February 17, 2015

**Subject: Comments on State Route 89/Fanny Bridge Community Revitalization Project**

Thank you for the opportunity to comment on the draft EIR/EIS/EA for the State Route 89/Fanny Bridge Community Revitalization Project (Fanny Bridge Project). The Friends of the West Shore (FOWS) works towards the preservation, protection, and conservation of the West Shore, our watersheds, wildlife, and rural quality of life, for today and future generations. Unfortunately, the EIR/EIS/EA contains numerous significant technical flaws in its analysis of multiple environmental impacts. New evaluations, data collection, and surveys are needed throughout, to such an extent that a revised draft EIR/EIS/EA (with recirculation and a 60-day public comment period) is needed in order to provide adequate public disclosure and analysis of the impacts of the project alternatives. In addition, although one of the key goals of the Fanny Bridge project has, for decades, been focused on reducing congestion at the Tahoe City Wye and on SR 89, the draft EIR/EIS/EA outright dismisses the most recent information regarding the traffic impacts of increased highway capacity – namely, the increase in V

**Figure 6.4**

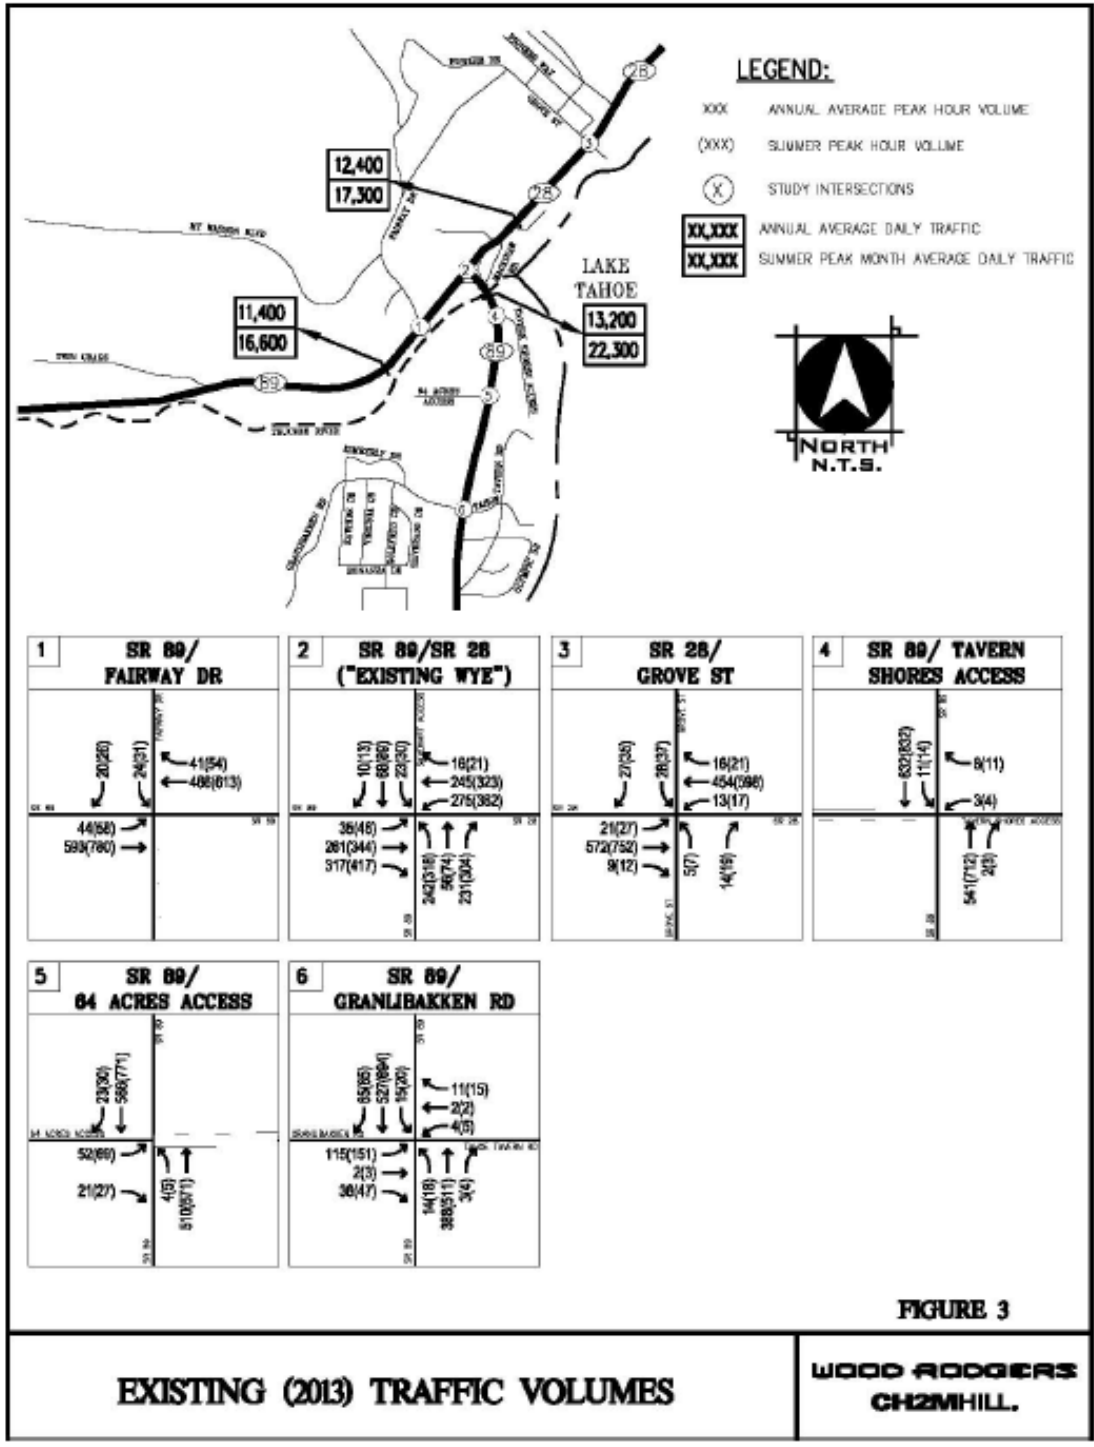
This graphic provides estimates for each county; note the Placer County increases are attributable to the Fanny Bridge Realignment Project. The estimated increased vehicle trips are noted as the ‘daily vehicle trips.’ Although the estimates to peak hour are not included, it is noteworthy that 730 trips/day is roughly double the general range in summer peak hour trips and more than double the general annual average peak hour trips, as noted in Figure 3 from Appendix G, the Travel Forecast and Operations Analysis Technical Memorandum:

Although the average trips per day and average peak trips per day are different units, the addition of 730 trips could be highly significant in light of the existing peak numbers.

*The EIR/EIS/EA must clarify the discrepancy between the 2008 estimated increases and the DEIR/EIS/EA statements that contradict them.*

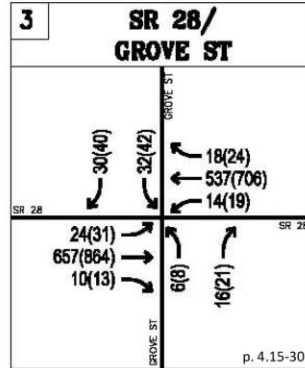
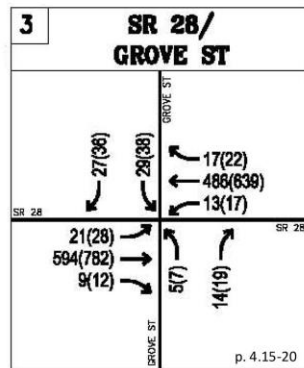
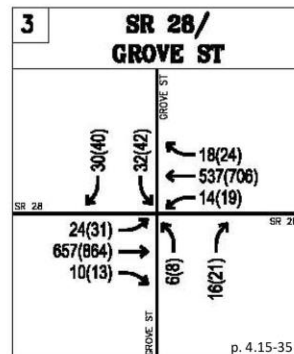
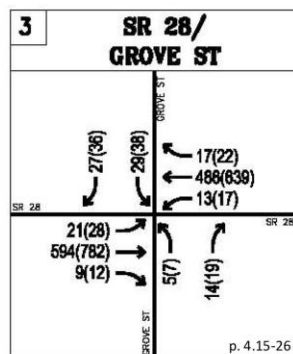
*The final EIR/EIS/EA must clearly assess the pedestrian and vehicle impacts at intersections in the Tahoe City area, including the cumulative impacts of each alternative and the increases in traffic from surrounding and foreseeable developments.*

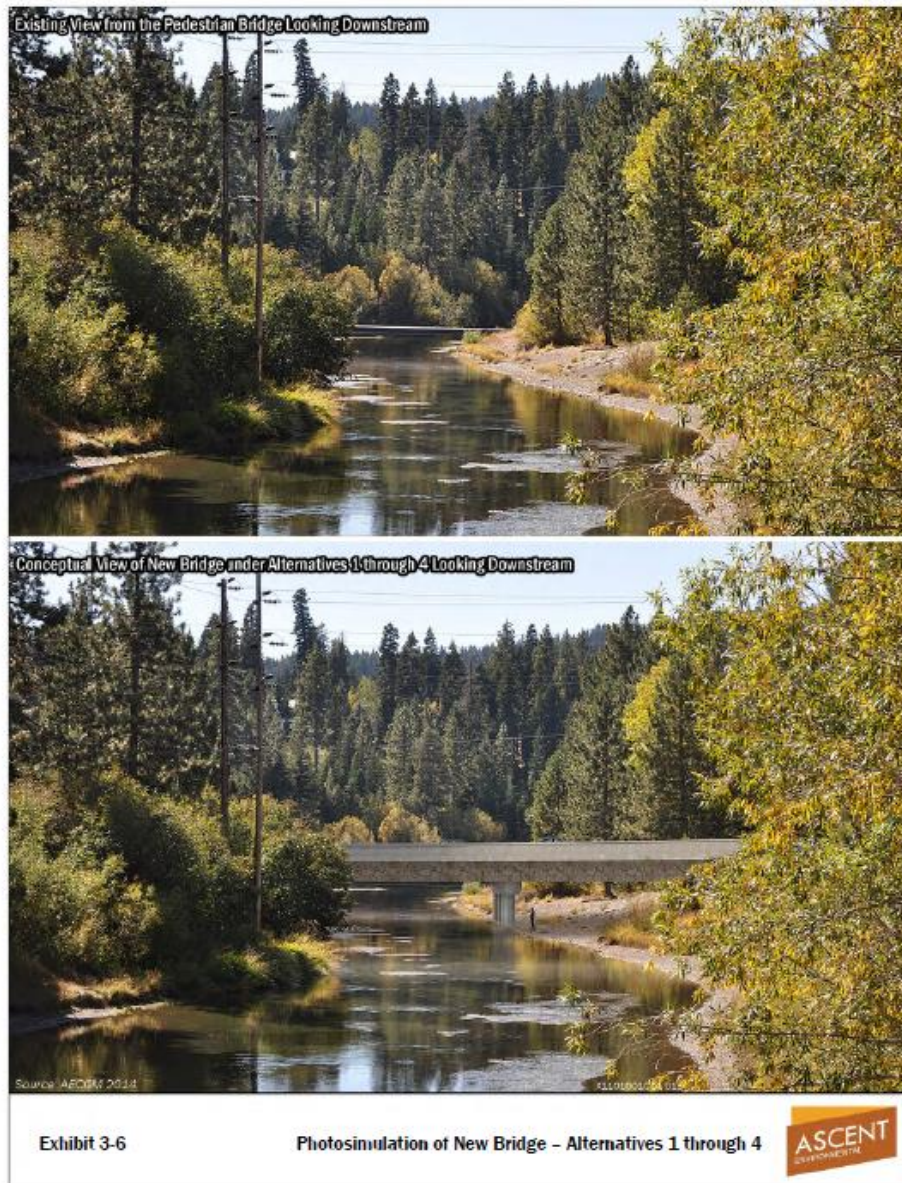
Although the EIR/EIS/EA’s description suggests a fairly unobtrusive image of the new bypass bridge,<sup>36</sup> the bridge will not be constructed without disturbance to the land nearby, nor will it only have one small vehicle on it as depicted in Exhibit 3-6.

Simulations must include the bridge with vehicles, from other angles, including both sides of the river, from surrounding mountaintops and Lake Tahoe (from any point where this raised highway may be seen), and views without as many trees, since trees will be cut for the project (and more trees tend to die during or shortly after construction; South Shore’s “Marriott/Heavenly Village” redevelopment is a prime example of this).

*The EIR/EIS/EA must include sufficient and correct depictions of the alternatives in order for the public to meaningfully understand and comment on the alternatives.*

**KOP 1:**

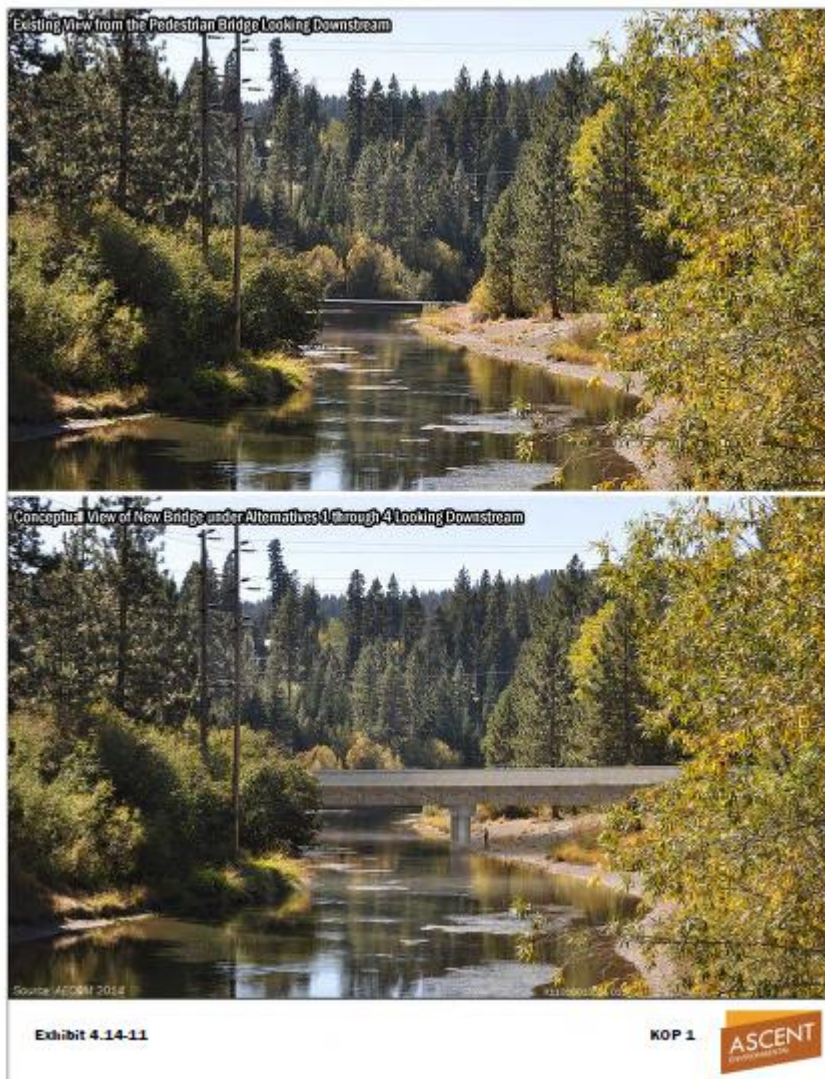
The EIR/EIS/EA presents the existing view from KOP 1, along with a simulated view of the bridge. However, the simulated view does not appear to represent a raised bridge, and it is unclear whether the bridge will be ten feet from the floor of the river, or ten feet above the bike path (which is presumed itself to be raised from the riverbed).

In addition, this image paints a far more pleasant picture than can be expected. For example, trees will be removed to construct this project. Vehicles will be crossing the roadway, creating dust and emissions. The EIR/EIS/EA must disclose the potential visual impacts of the project. Although the following images below have not been professionally created, they are included to represent the types of simulations that should be included in the DEIR/EIS/EA to better reflect the reality of what the impacts could be. The first image includes the EIR/EIS/EA's simulated bridge from KOP 1, however vehicles, emissions, and other highway debris have been added. The second image below includes a higher bridge, roughly raised another ten feet above grade level at the sides of the river, as it is unclear from the EIR/EIS/EA exactly how high the bridge will pass over the river.

KOP 2:

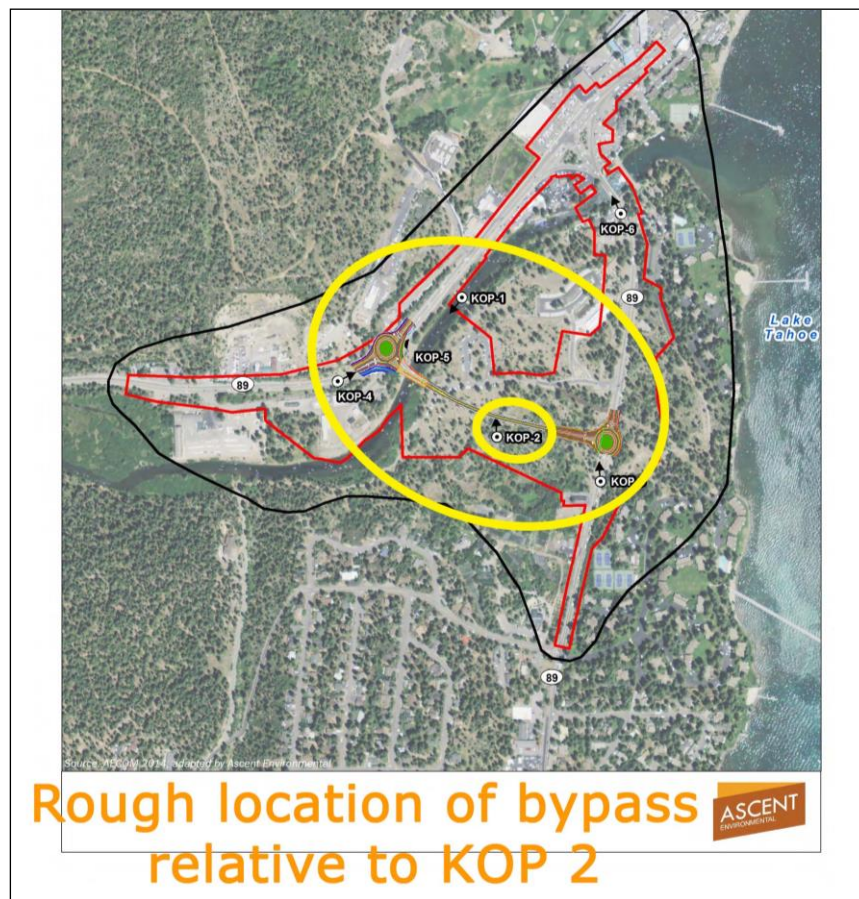
Oddly, the DEIR/EIS/EA includes no visual assessments of the impacts to KOP 2, which is an area representing the undeveloped forested section of the 64-acre Tract. The DEIR/EIS/EA acknowledges this point: *“The view from KOP 2 consists of a forest scene that provides relatively intact forest vegetation, which does not contain any urban features.”*<sup>37</sup> Although Exhibit 4.14-10 identifies the location of the KOPs, and the DEIR/EIS/EA notes the bypass *will be visible from KOP 2 and other points in the 64-acre tract,*<sup>38</sup> the DEIR/EIS/EA fails to include a picture representing the existing view from KOP 2, let alone a simulation of what it would look like with the bypass in Alternatives 1-4.

In a rough comparison of the location of the new bypass to the KOP 2, it appears the bypass would be built in the same location as the KOP 2. The EIR/EIS/EA needs to clearly show the before and after impacts to this observation point.

***KOP 5:***

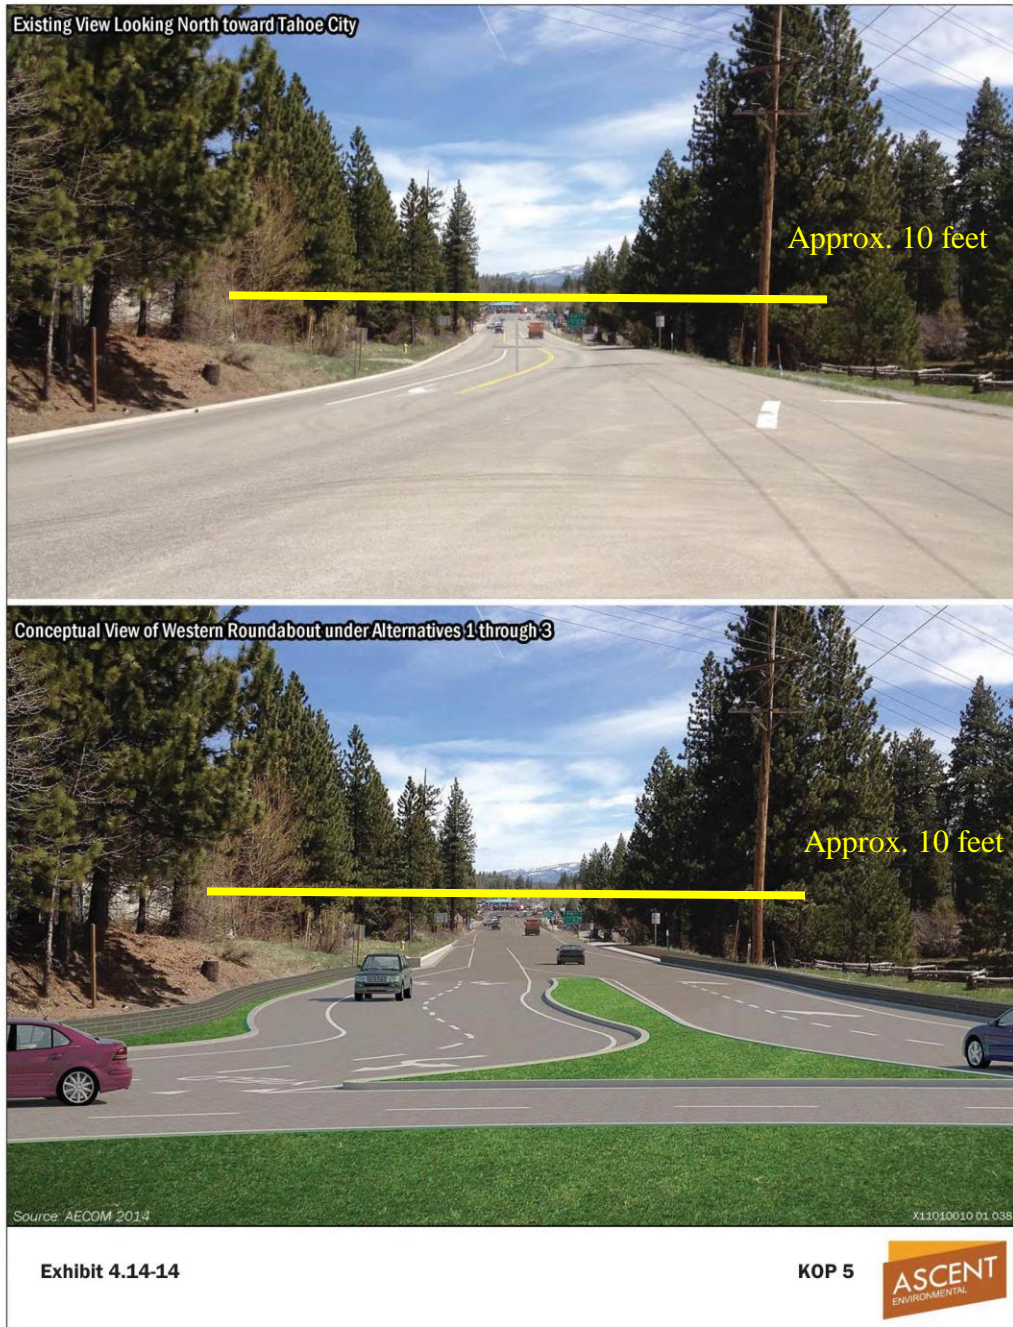
A local Tahoe City resident placed ten foot poles at the intersection labeled KOP 5 in the EIR/EIS/EA to represent where an elevated embankment would be. As the resident's picture reflects below, the elevated bypass would significantly change the views in this area.

However, the KOP 5 simulation in the EIR/EIS/EA appears to be based on ground level. If this bypass will be elevated above the existing ground level, the visual simulations need to clearly reflect the changes.
